**DECISION NOTICE FOR OPERATIONAL WORKS
- STAGE 6A & 6B OCEAN BREEZE ESTATE – BONNIE DOON**

**DECISION NOTICE FOR OPERATIONAL WORKS – STAGE 6A & 6B
OCEAN BREEZE ESTATE – BONNIE DOON**

Operational Works (Engineering) excluding Lighting Works & Landscaping Works

Lot 901 on SP285536

PROVISIONAL PAVEMENT DETAILS

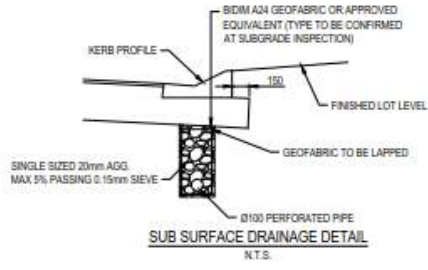
- c. In respect of the provisional pavement details, the applicant is to confirm CBR results from previous stages and provide this information on the drawings at the pre-start meeting.

TITLE		SEWAGE PUMP STATION DETAILS	
SCALE	150/1	ISSUED BY	IH132900-CI-DG-0016
REV		B

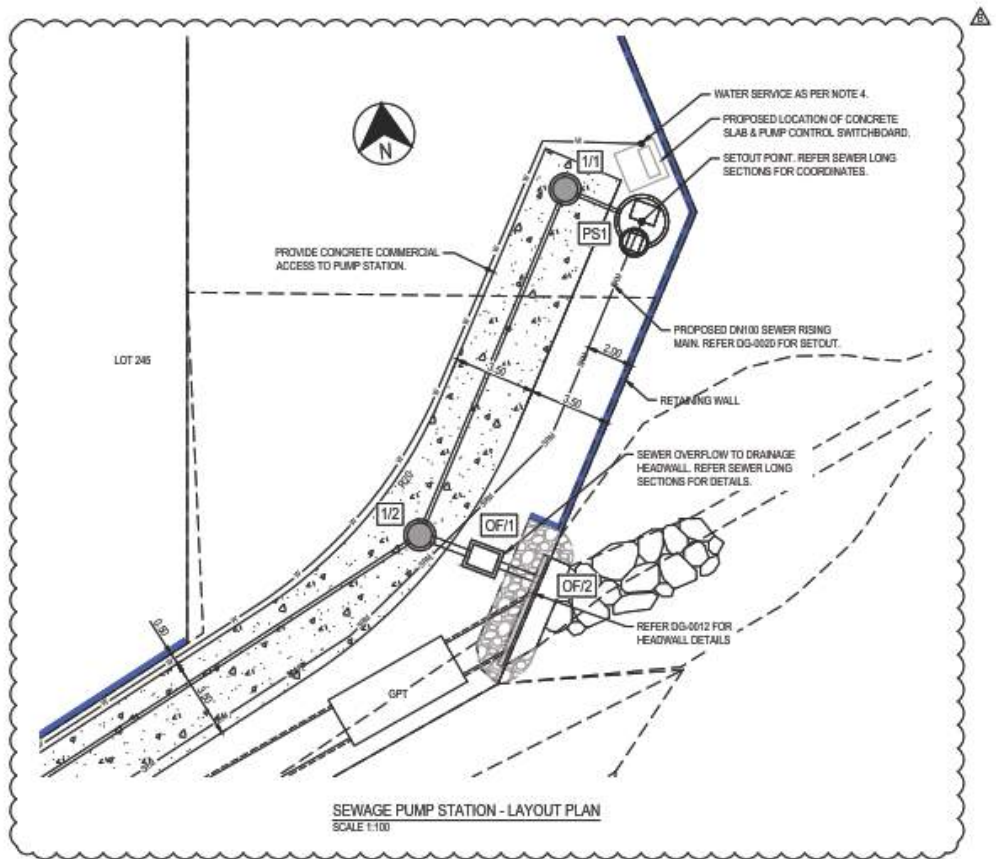
- c. Sewage Pump Station; the proposed FRP Packaged Sewage Pump Station is accepted in principle, however the applicant must provide Council with a copy of the "For Construction" drawings for the pump station prior to placing the order with the supplier. Council approval of the "For Construction" plans will be a holdpoint on this item.

- g. Amended drawings are required for the overflow detail to confirm the location of the valve. Council is not permitted to have an open overflow that may allow storm water ingress or uncontrolled release of sewage.

- h. The applicant is to provide calculations of the overflow operation including hydraulic grade line based on downstream tail water level at the outlet. Note the outlet level in a sewage overflow scenario will not be the same as the hydraulic grade level for the stormwater minor flow system. The additional calculations are to confirm sufficient freeboard exists to all residential lots in the local sewage catchment in the event of a sewage overflow for the outlet at the proposed location and levels.

LONGITUDINAL SECTION SEWER RISING MAIN
SCALE 1:50H

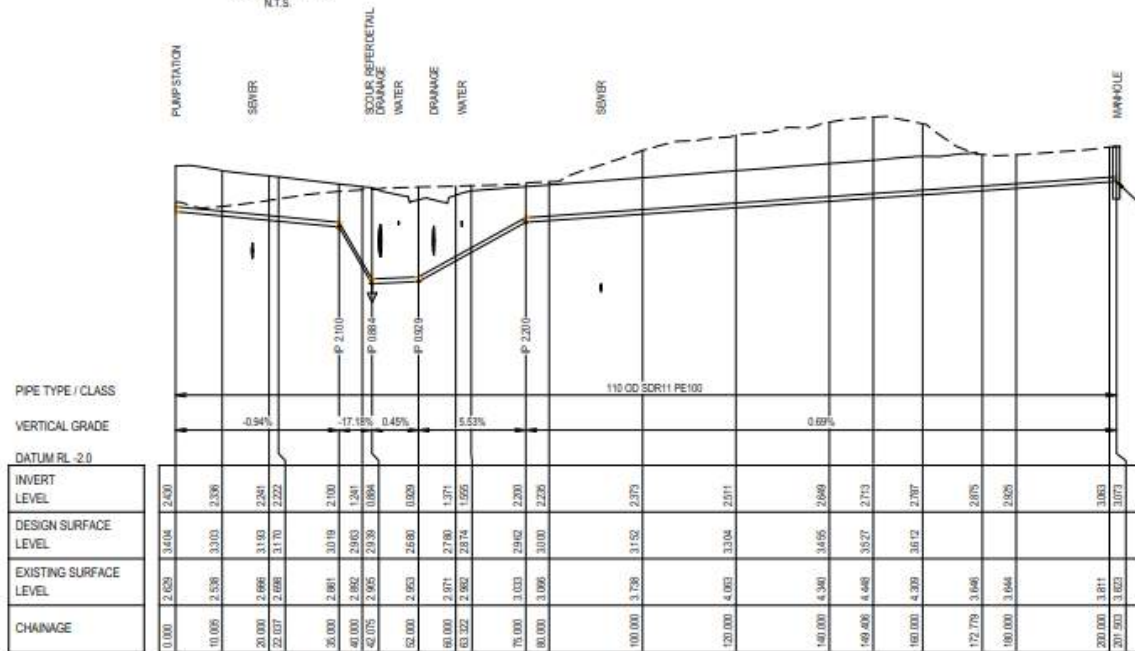
- i. The sewer rising main is to be relocated to the eastern side on Road 01 to avoid the footpath. Council's preference is for the road crossing (If required), to be in the vicinity of Chainage 170m. The revised rising main location is to be shown on amended drawings issued "for Construction". The drawings must be provided prior to the prestart meeting.

JONPA PTY LTD PROJECT: OCEAN BREEZE ESTATE - COOYA BEACH - STAGES 5A & 5B SHEET: WATER RETICULATION			
DESIGNER: [Name] CHECKED: [Name]		DRAWN: [Name] DATE: 08/12/17		PROJECT MANAGER: [Name]		APPROVED: [Name] DATE: 08/12/17		SCALE: 1:500 (A1)		SHEET NO: IH132900-CI-DG-0021

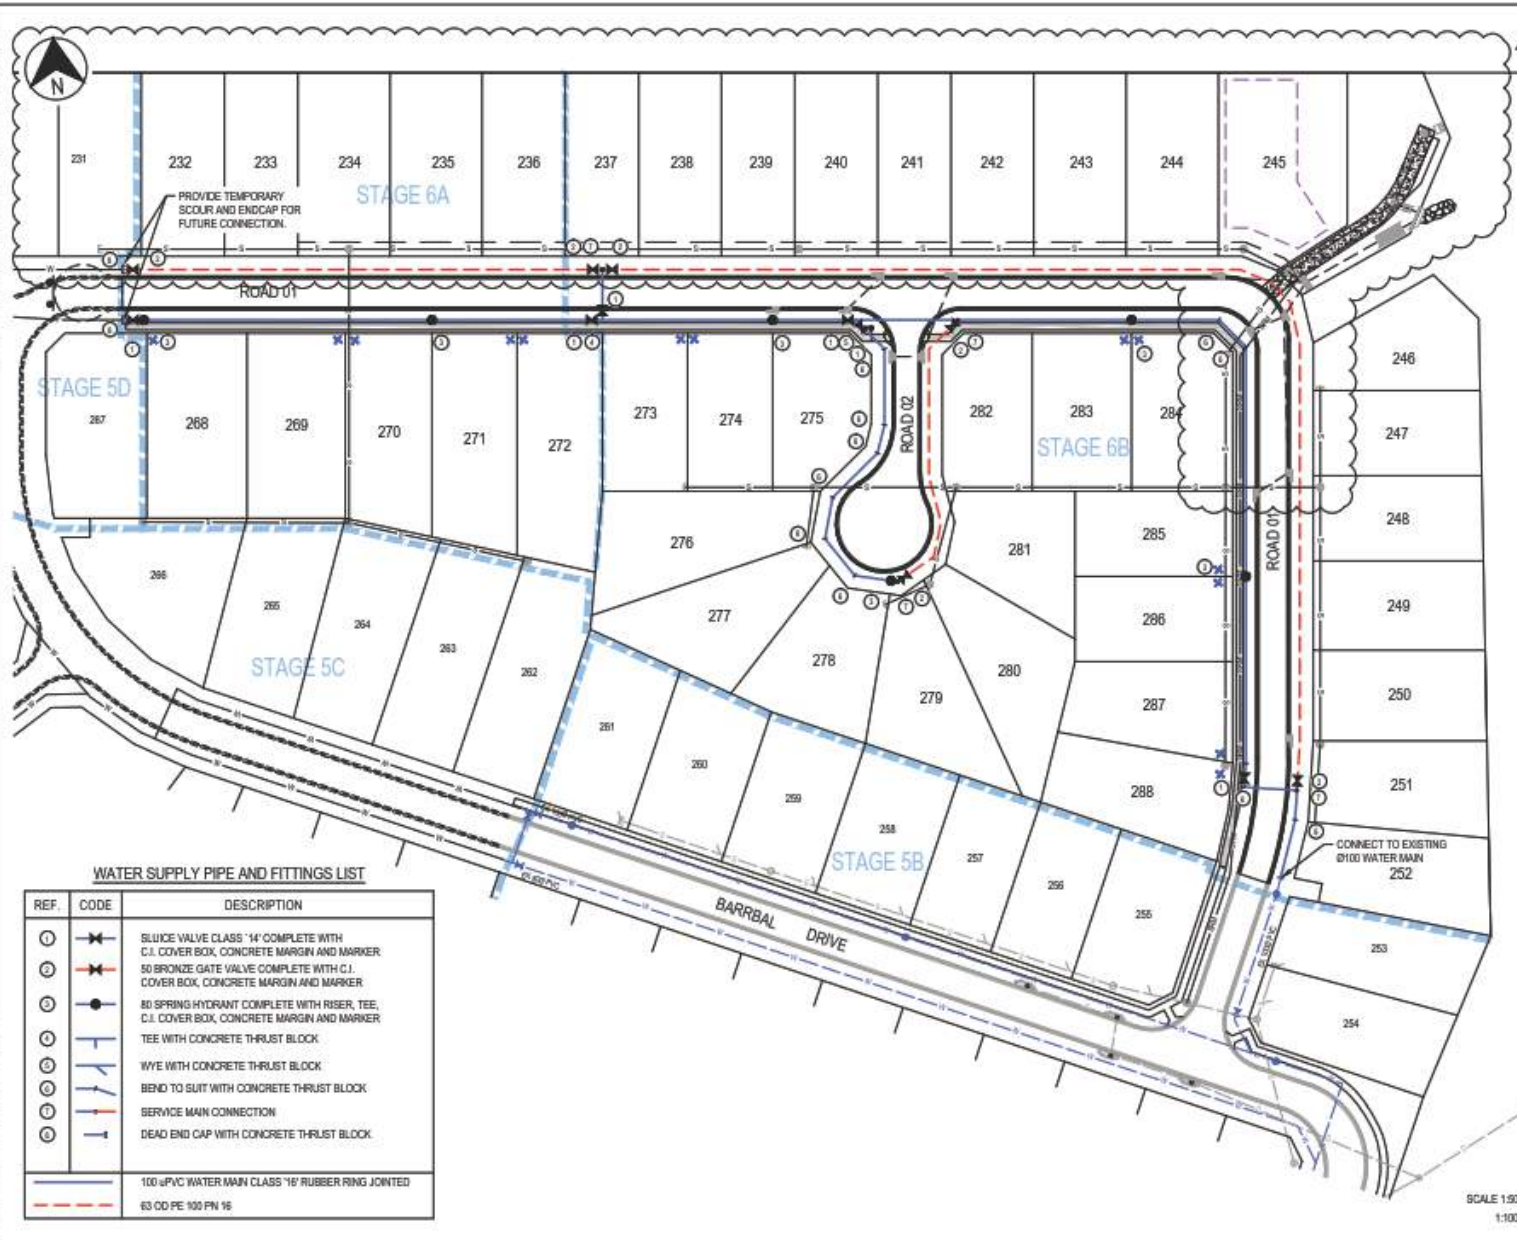
- a. Include on the water reticulation plan the location of light pole footings and confirm the clearance between the footing and the water main. The revised drawing is to be endorsed by Council prior to commencement of water reticulation works.
- b. The minimum clearance between light pole footings and water mains are to be in accordance with WSA and verified and recorded by the consulting engineer during construction.
- c. 80mm conduits are to be supplied and installed under concrete footpaths for the purpose of future water service. The location of the conduit shall be at the opposite boundary to where the electrical pillar box is located.
